Road Safety Audit Review

Town:	Londonderry	Date Reviewed:	October 8, 2015
Route:	VT 100, Middletown Rd and Main St	Mile points:	Area of mm 2.99

The location of this RSAR is the intersection of VT 100, Middletown Road and Main Street in South Londonderry.

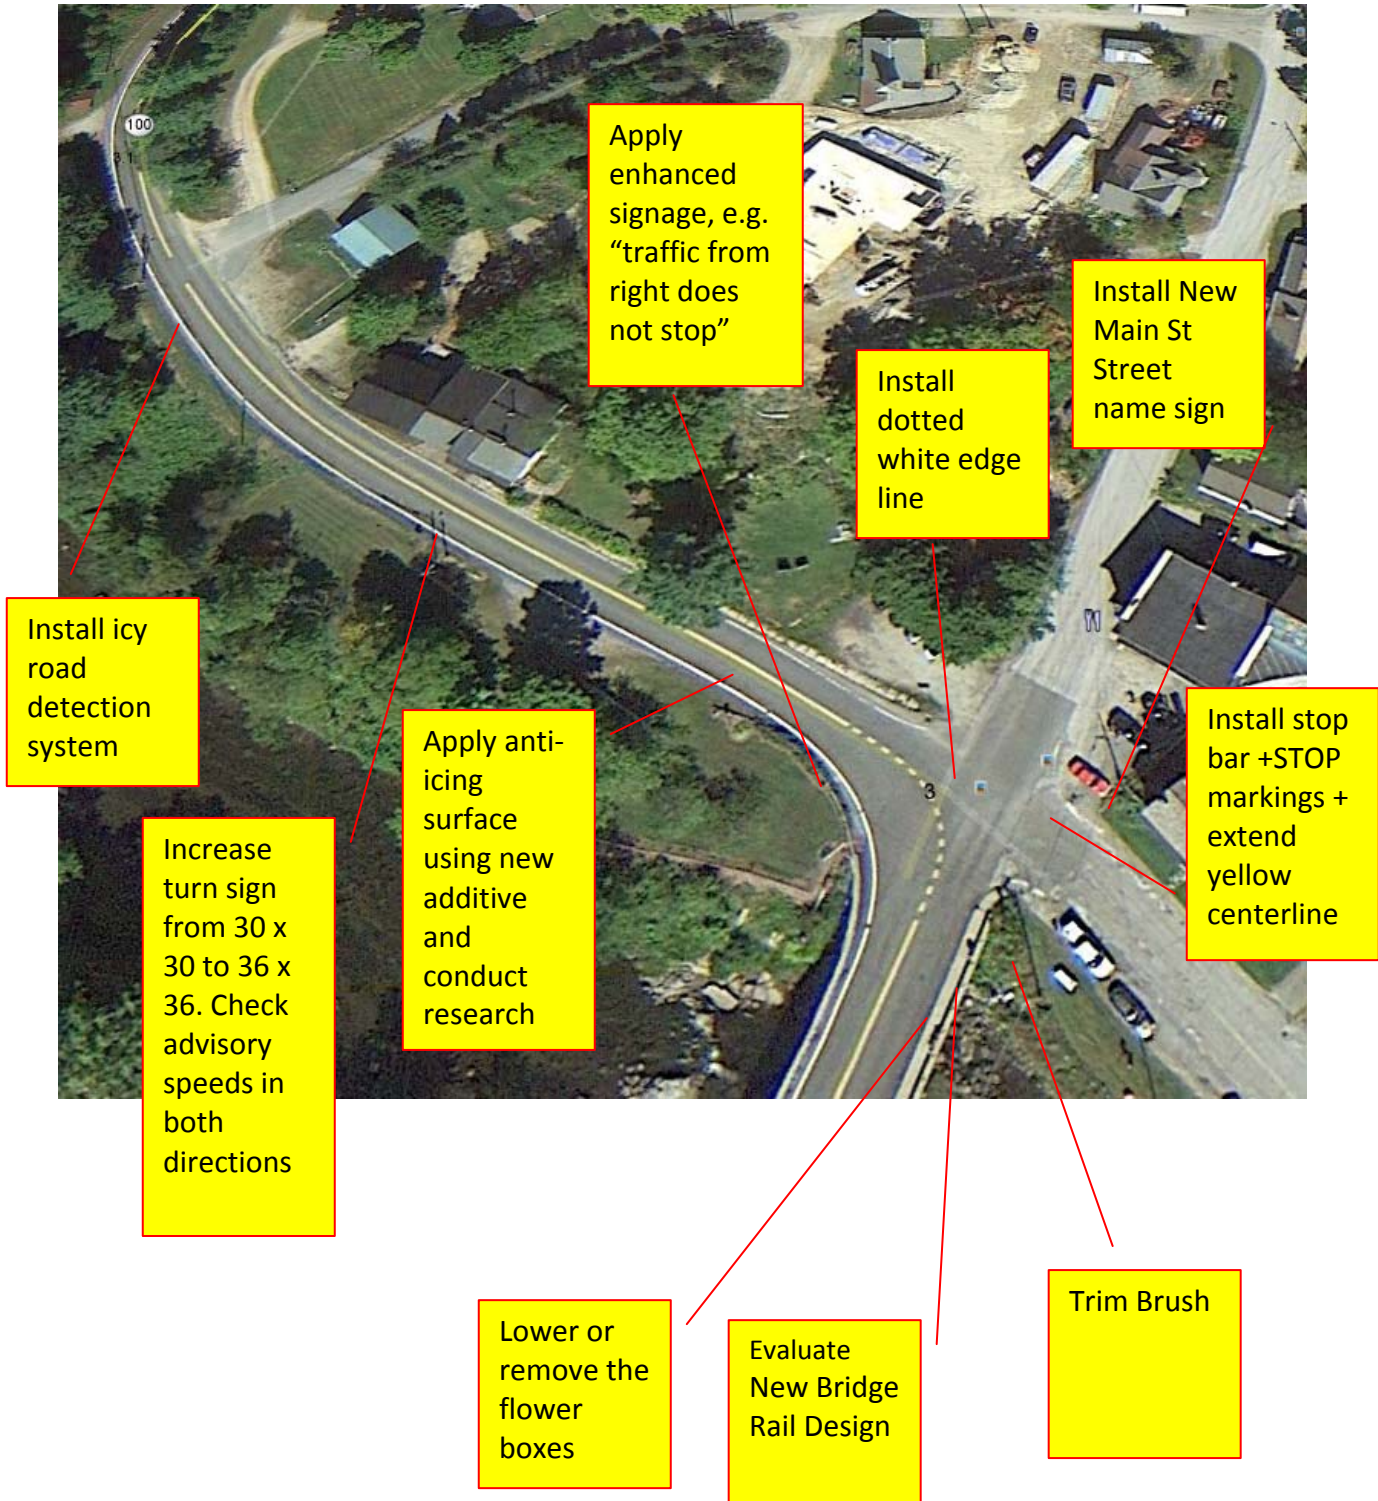
The second action that was evaluated is controlling the intersection with stop signs on all approaches. Clearly, stopping all traffic at this intersection from all approaches would eliminate the confusion that some VT 100 southbound motorists who want to cross the intersection onto Main St have with respect to them having the right-of-way (2nd concern previously discussed).

On the other hand, the Manual on Uniform Traffic Control Devices provides guidance as to when it is appropriate to control traffic with multi-way stop signs. One of the leading criteria is that the traffic volumes be approximately equal on all approaches. Another set of criteria are bundled into warrants. A formal warrant analysis was performed by VTrans. Based on the volumes and crash criteria, it was found that multi-way stop operation was not warranted at this location. The results of the warrants are presented at the end of this report. Based on this information alone, multi-way stop controlled for this intersection cannot be supported.

While the main warrants do not support the application of multi-way stop control, the Manual on Uniform Traffic Control Devices provides other guidance that may be considered. One of these other conditions is the need to control left-turn conflicts. Crossing over onto Main St from VT 100 southbound could possibly be considered a left turn maneuver since the continuous (through) movement is along the curve on VT 100. Another condition would be where a road user, after stopping, cannot see conflicting traffic and is not able to negotiate the intersection unless conflicting cross traffic is also required to stop. This condition could possibly describe the first concern mentioned earlier.
